STAFF RECOMMENDATION
1112 Chapel Avenue
October 17, 2018

Application: New Construction—DADU
District: Eastwood Neighborhood Conservation Zoning Overlay
Council District: 06
Map and Parcel Number: 08302006900
Applicant: Jon Knight
Project Lead: Melissa Baldock, melissa.baldock@nashville.gov

Description of Project: Application is to construct an outbuilding to be used as a Detached Accessory Dwelling Unit (DADU). There will be a distance of ten feet (10') between the back of the house and the DADU.

Figure 2. Site plan showing the outline of the property lines.

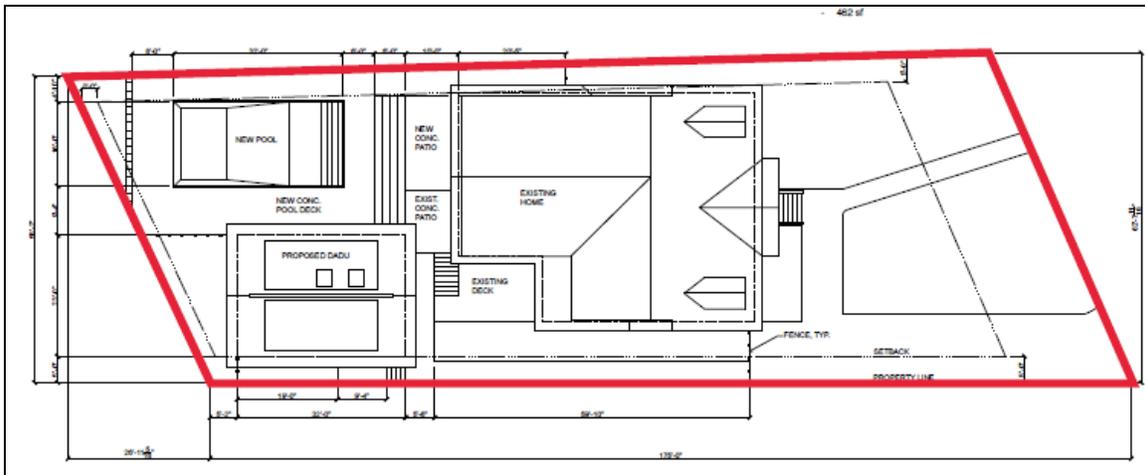
* The design guidelines state that there should be a minimum of twenty feet (20') of separation between the back of the house and the outbuilding. However, the Commission has reduced the distance to as little as ten feet (10') when the lot is unusually shallow or oddly-shaped, or where there are other atypical circumstances. In this case, Chapel Avenue is slanted, creating slanted front and rear property lines (Figure 2). The house is situated so that it is perpendicular to the side property lines – i.e. it doesn't slant with Chapel Avenue. The front setback varies from forty-eight to sixty-six feet (48'-66'), which is deeper than other neighboring historic houses on this side of the 1100 block of Chapel Avenue. In addition, only four feet (4') of the garage is just ten feet (10') from the back of the house; the other nineteen feet (19') of the DADU is more than thirty feet (30') from the back of the house.

Because of the odd shape of the lot, the deep front setback, and the fact that only four feet (4') of the DADU is less than twenty feet (20') from the back of the house, staff finds that the location and distance between the structures is appropriate.
